Access Compliance Report

Public Rights-of-Way

Intersection ID: 47853	Main Street: STONE_PORCH_RD	Cross Street: EL_CAMPO_DR	Location: NE
ADA ID: 22741A2C3F50	Ramp Type: Perp	Initial Pass/Fail: Fail	Overall Compliance: No
Severity Score: 33.75			
Codes/Mitigation Info/Possible Solution		Field Measurements/Component Compliance

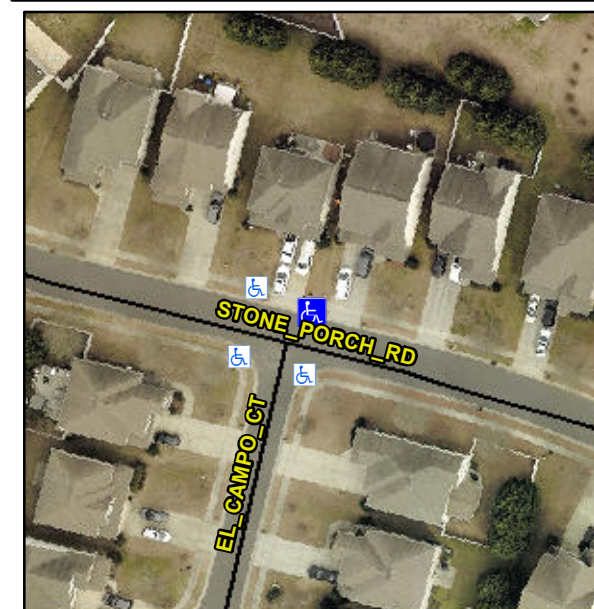
Not Found, R304.5.1, R304.2.2

Compliance	Description	Data	Compliance	Description	Data
N/A	Ramp Length (in)	48.0	No	Ramp Slope (%)	12.9
No	Ramp Width (in)	45.0	Yes	Ramp XSlope (%)	1.1
N/A	Flare Type LT	N/A	N/A	Flare Type RT	N/A
N/A	Flare Slope LT (%)	N/A	N/A	Flare Slope RT (%)	N/A
N/A	Flare Traversable LT?	N/A	N/A	Flare Traversable RT?	N/A
N/A	Landing Length (in)	N/A	N/A	DWS Provided?	N/A
N/A	Landing Width (in)	N/A	N/A	DWS Contrast?	N/A
N/A	Landing Slope (%)	N/A	N/A	DWS Length (in)	N/A
N/A	Landing X Slope (%)	N/A	N/A	DWS Full Width?	N/A
N/A	Landing Curb? (Y/N)	N/A	N/A	DWS Offset (in)	N/A
N/A	Shared Landing?	N/A			
N/A	Gutter Ponding?	N/A	N/A	Gutter Slope (%)	N/A
N/A	Gutter Lip Ht (in)	N/A	N/A	Gutter X Slope (%)	N/A
N/A	Painted X Walk1?	No	N/A	Painted X Walk2?	N/A
	X Walk 1 Direction	To SW		X Walk 2 Direction	N/A
N/A	X Walk 1 Width (in)	N/A	N/A	X Walk 2 Width (in)	N/A
	X Walk 1 Slope (%)	3.2		X Walk 2 Slope (%)	N/A
	X Walk 1 X Slope (%)	2.4		X Walk 2 X Slope (%)	N/A

Remove & Replace Entire Ramp.
